Service Letter No. 437

SUBJECT: Replacement of Fuel Gage Assembly

MODELS AFFECTED: PA-24-400 Comanches, Serial Numbers 26-2 to 26-60 incl., 26-65 to 26-69 incl., 26-71 to 26-79 incl., 26-82, 26-84 to 26-87 incl., 26-89, 26-90, 26-92 to 26-96 incl., 26-114, 26-123, 26-124

GAGE ASSEMBLY -
ELECTRIC FUEL (tank unit)

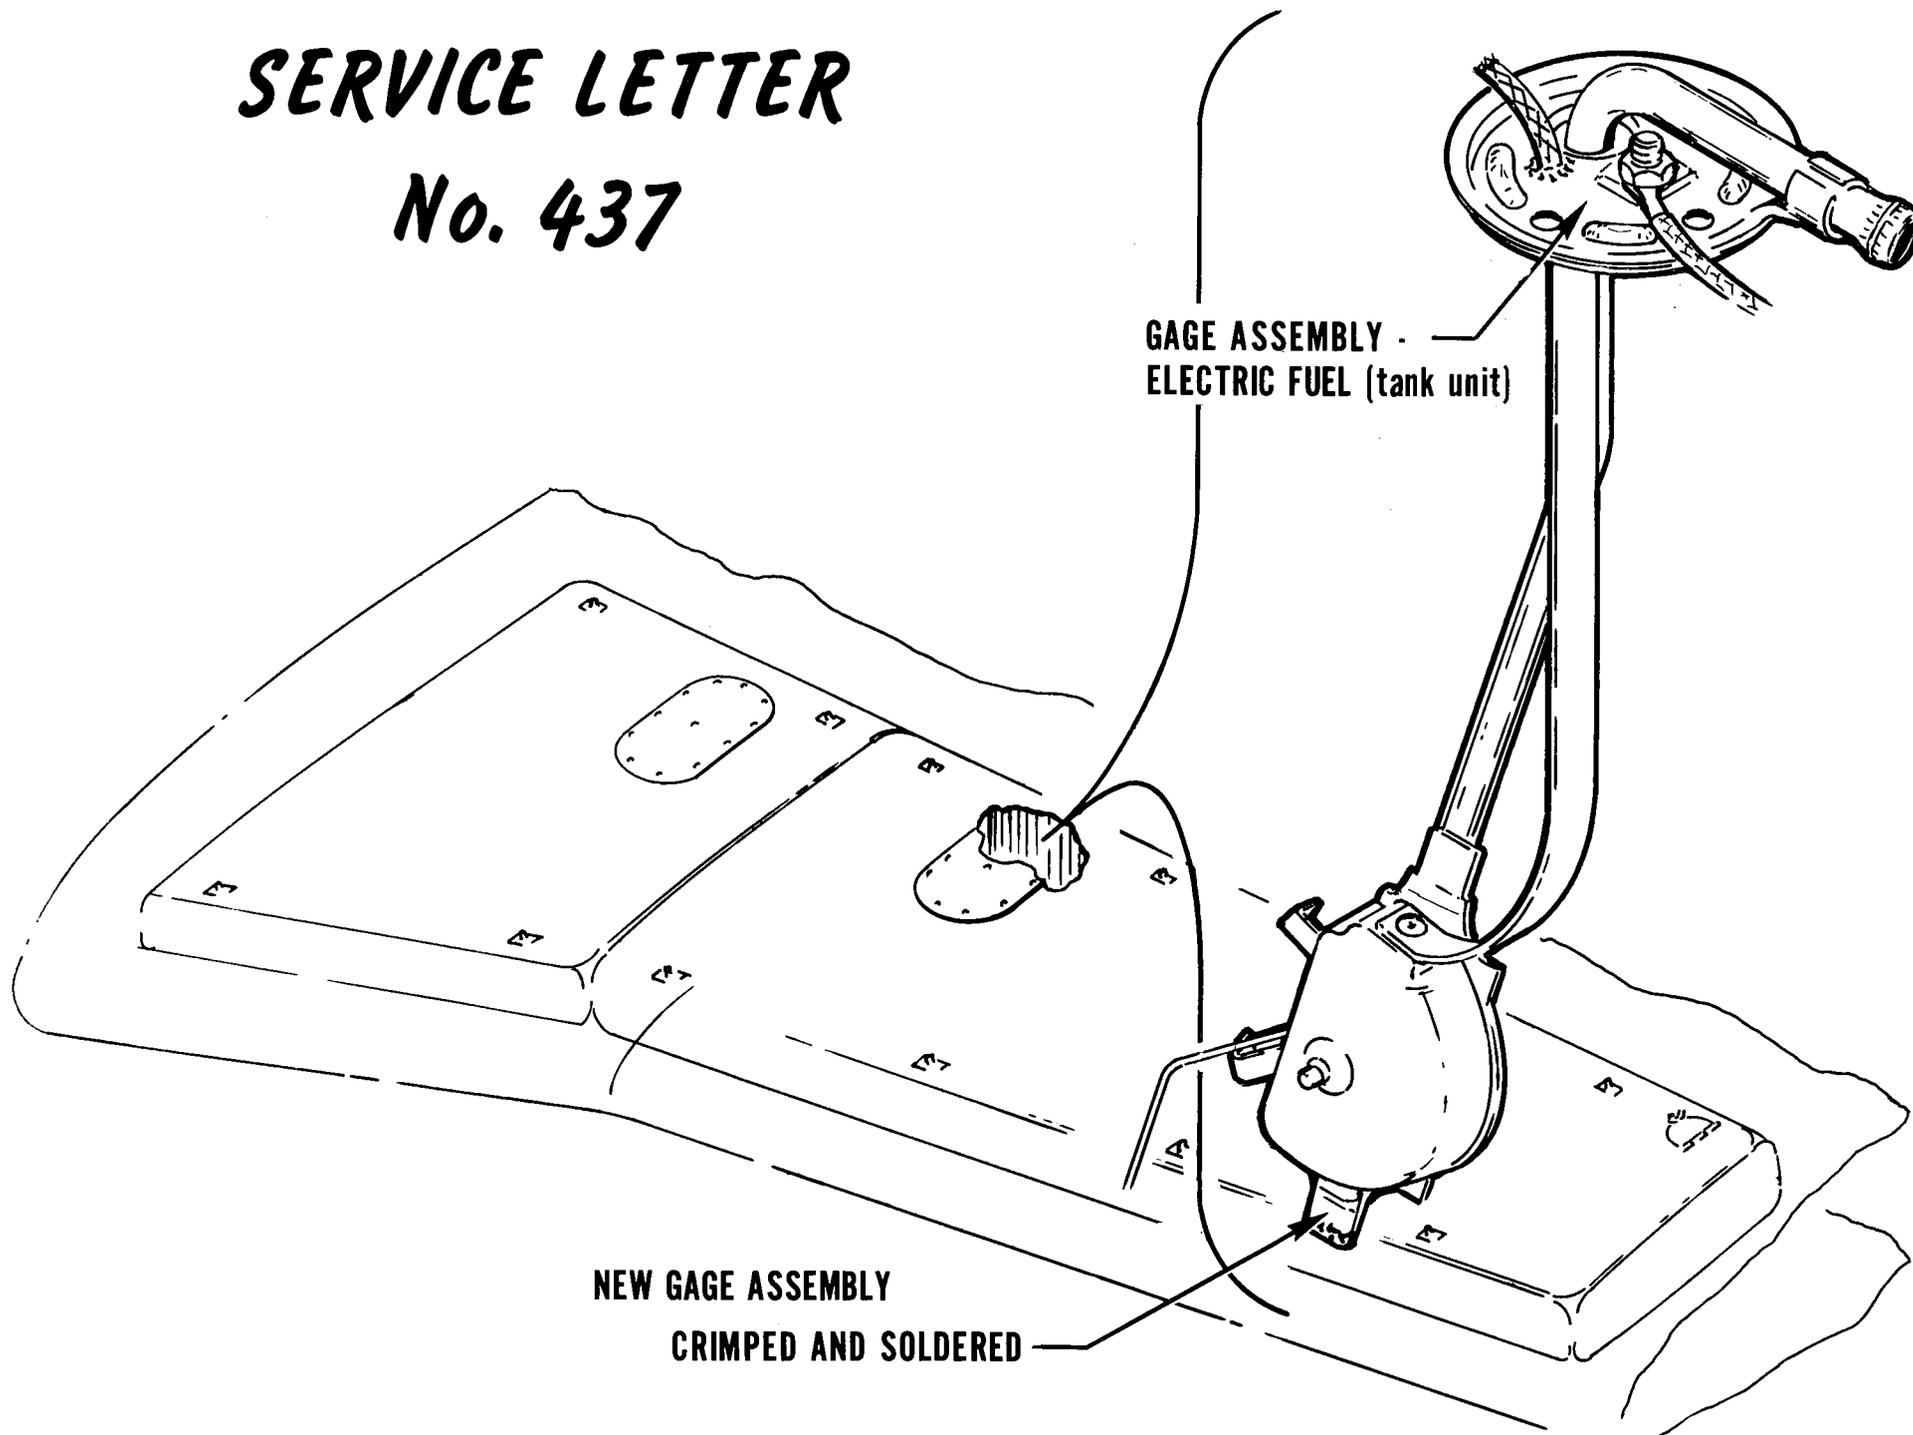
Reports of corroded inboard fuel gage assemblies in the outboard fuel cell makes it necessary to replace this unit. See sketch on the reverse side of this letter for proper location of fuel gage assembly.

NEW GAGE ASSEMBLY
CRIMPED AND SOLDERED

Replacement fuel gage assemblies should be ordered under part number 450 771 (2 per airplane).
